SUBJECT: Floor & Décor (DR2022-0078 / PD2022-0006) - Additional Public Comments and

Updated Oregon Department of Transportation (ODOT) Comments

Subject: Floor & Décor Application # DR2022-078/PD2022-0066

DR 2022-0078/PD 2022-006: Floor & Décor Comments

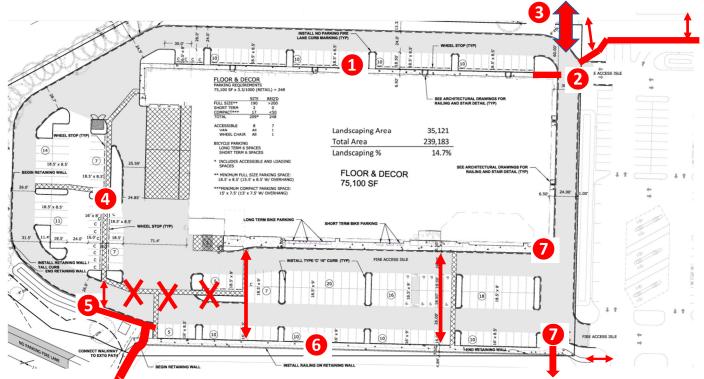
- 1 This parking stall should not have wheel stops as they would be in the pedestrian path from cars to sidewalk. Since the area is either paved asphalt or concrete extend the concrete sidewalk to 8.42' and reduce the parking stall to 16' which accomplished that same outcome with the same pavement without the tripping hazard (not complying with ASTM 1636-21 which says to avoid wheel stops). The wider sidewalk has greater utility than a longer parking space with a wheel stop in it.

- The sidewalk terminates in an illogical location. The sidewalk should extend north with ADA curb ramps across to the side adjacent to then north where restaurants, retail and Peppertree Inn are being built (noted by red stubs/arrows)

- There is likelihood in the future that the Peppertree Inn driveway will be limited to right-in/right-out only access as it is too close (only 250') to the OR 217 NB/Allen off-ramp to meet OAR 734-051-4020(8) which specifies 750 feet spacing to full access points from interchange off-ramps. Because of this, the grade in the area just south of the three parking spaces (on the site immediately north) should be set up to allow a future potential shared access point (24 feet). This shared access could be established now or later when criteria demand the change (depending upon the City and ODOTs consideration).

- The combination of wheel stops in a pedestrian space is a potential tripping hazard. This should be raised sidewalk that consumes the same space as the walkway plus the overhang areas eliminating the wheel stops. No increased paved area, just concrete sidewalk replacing paved asphalt with ADA curb ramps at each end point.

- Pedestrian space in the middle of vehicle aisles is not acceptable (take them out red x's). Replace them with crossings (potentially raised pedestrian crossings (3 to 6 inch) with ADA access across the parking area where the three arrows indicate lining up directly with doors (providing speed management also). A new sidewalk linking to the Fanno Creek Greenway Trail (minimum 6' behind the curb) should be added.

- The vehicle overhang wipes out the pedestrian way/Fanno Creek Trail link. The sidewalk nneds be 10 feet to properly address vehicle overhang and railing shy distances. This should extend to the site to the north and connect to the ADA curb ramps.

- 7 ADA ramps at corners NOTE: trail to east (8') missing along the north shore of the water quality facility

- 37. Provide plans showing an approximate 9.5-foot sidewalk (with 5-foot minimum clearance) on the west side of the building by eliminating wheel stops and reducing the parking space length (from 18.5 to 16 feet). Modify sheet C3.2 accordingly. This is shown as item 1 on the attached sketch.

- 38. Provided plans showing walk access from the NW corner of the building to the adjacent sites (Phase 1, Peppertree Inn and Allen Boulevard). Sheet C3.2 needs to be modified accordingly as it only shows one pedestrian connection on the far eastern end of the site, not evenly spaced, leaving space that is not separated from vehicles (60.05.20.3.C). This addresses code needs for providing linkages to the adjacent stairways to Peppertree Inn (2) and to the pathway from Allen Boulevard that terminates midway between the Phase 1 site, behind three parking spaces just north into the Phase 1 site. This includes

two missing ADA curb ramps not shown and extension of the sidewalks along the west side of the build northward to the circulation road. This is noted as item 2 on the attached sketch.

- 39. Provide plans showing a 7.5' (western end) to 9.5' (eastern end) sidewalk between parking spaces near the southern end of the building by removing all wheel stops and provide an ADA curb ramp as either end (adjacent to the trash enclosures on the west end, at the end of the parking island on the east end). This is noted as item 4 on the attached sketch.

- 40. Provide plans showing a 6-foot sidewalk from the end of the existing Fanno Creek Trail to the east curb line of the parking lot and extend it (~60 feet) to line up with a crossing to the pedestrian path noted in item #39 above, including an ADA curb ramp. Raise the pedestrian crossing 3" (10' wide) with 6' transitions in the vehicle space up and down. Extend a gutter from the raised crossing transition 13 feet into the storm water quality detention area. This is noted as item 5 on the attached sketch.

- 41. Provide plans showing the pedestrian path in the middle of the vehicle circulation area removed and replace vehicle separated spaces next to parking with landscape areas. Extend the southern pedestrian path through the parking lot straight to the pathway adjacent to the water detention facility east of the site. Provide ADA curb ramps for all raised areas at crossings of parking aisles (4). Move northern pedestrian path to the south to align with building doorways & provide an ADA curb ramp. Align path with accessible parking loading space, including widening the landscape island in the central parking bay. Relocate landscape parking island on the eastern parking row to south and provided two ADA curb ramps to six-foot sidewalk connecting to pathway adjacent to water quality detention facility. Noted as item 5 arrows on the attached sketch.

- 42. Provide plans showing a 10-foot path (not 7.5 feet) on the eastern end of the site connecting the Fanno Creek Trail north toward Allen, along the water quality detention lake. With railings and vehicle overhang, people cannot pass each other creating an inaccessible path for all users (walkers, strollers, wheelchairs, blind people with canes, people with umbrellas, children on bikes). This is noted as item 6 on the attached sketch.

- 43. Provide plans showing the pedestrian ways connected up at the northeastern corner of the building with ADA curb ramps with 6-foot sidewalks. This is shown as item 7 on the attached sketch.

- 44. Provide plans showing the grading for a pedestrian path (8-foot) from the northeast corner of the

site across the northern end of the water quality detention lake completing the loop around the lake.

45. Provide plans showing the shared access connection to the Peppertree Inn site adjacent to the existing stairway aligned with the Floor & Décor northern vehicle circulation aisle to address shared access agreement and future requirements that can be imposed by OAR 734-051-4020(8). This is noted as item 3 on the attached sketch (also see image of the location today, looking east).

Exhibit 3.21 ALTA / NSPS Land Title Survey Exhibit 4.2 Updated ODOT Comments

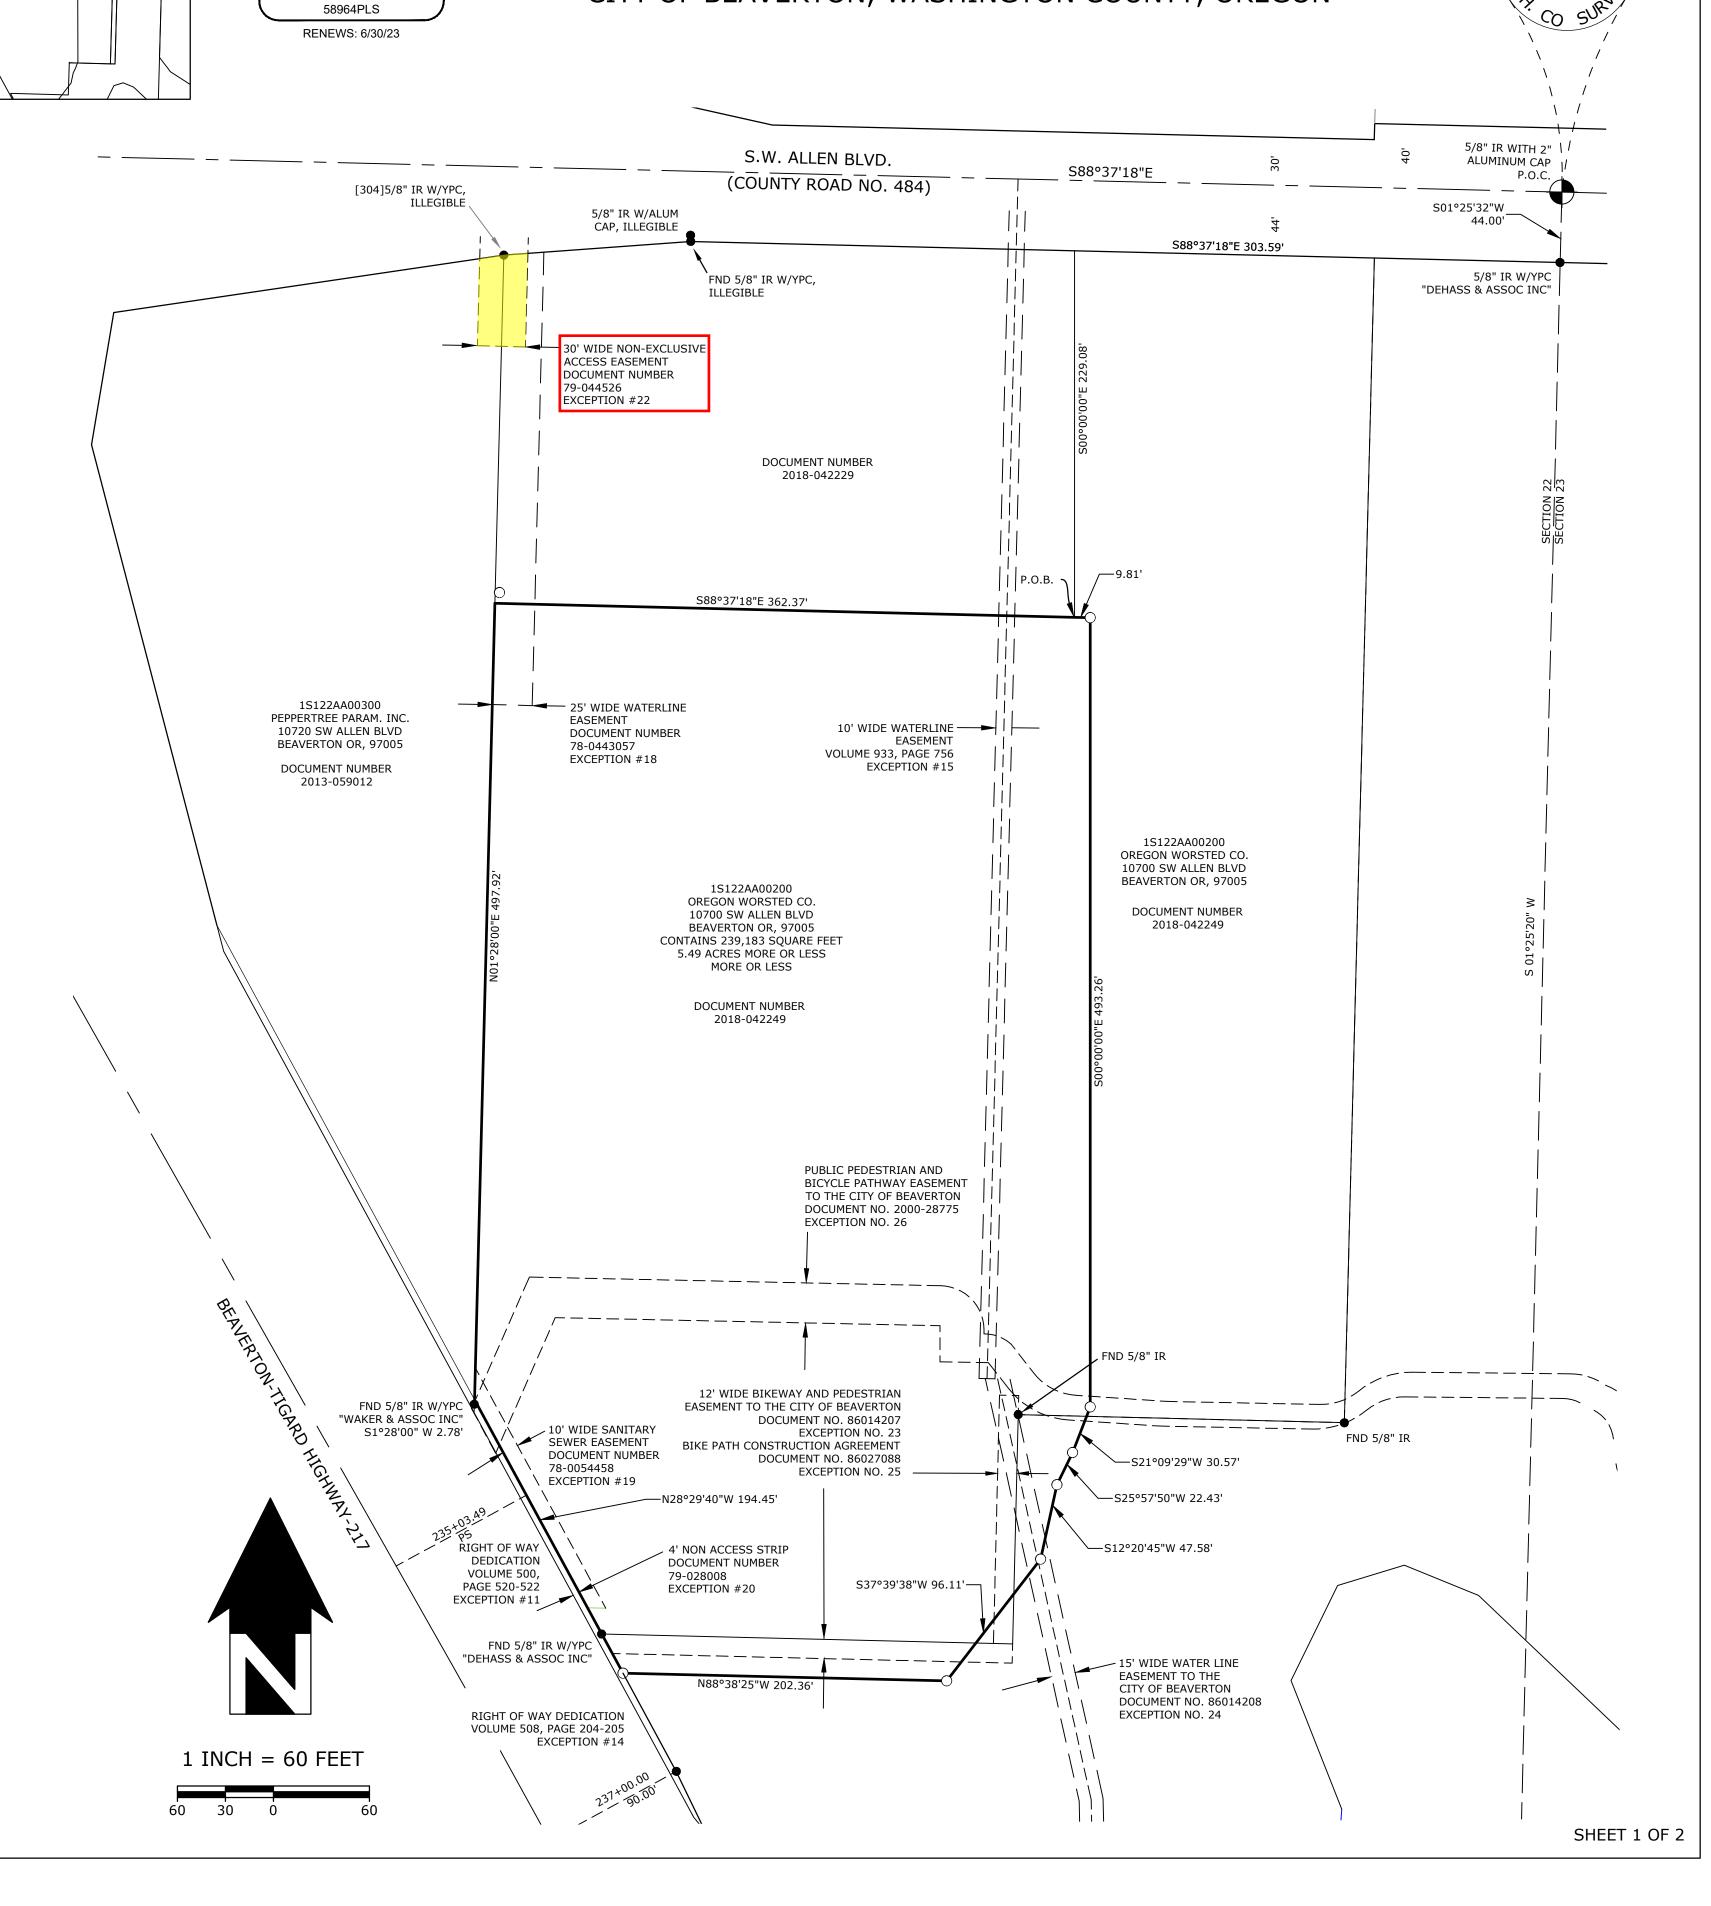
The Peppertree Inn property is not proposing to redevelop at this time and is not included in the Floor & Décor proposal. As shown on Exhibit 3.21, the cross over access easement is located at the northwest corner of the Phase 1 Allen Redevelopment site and is located outside of the Floor & Décor project area. Furthermore, Floor & Décor is not proposing to create a new access with this application; instead, Floor & Décor proposes to utilize a previously approved access on the Phase 1 site (a commercial driveway on SW Allen Boulevard). Therefore, the applicant is not required to design a shared access with the Peppertree Inn site for this application.
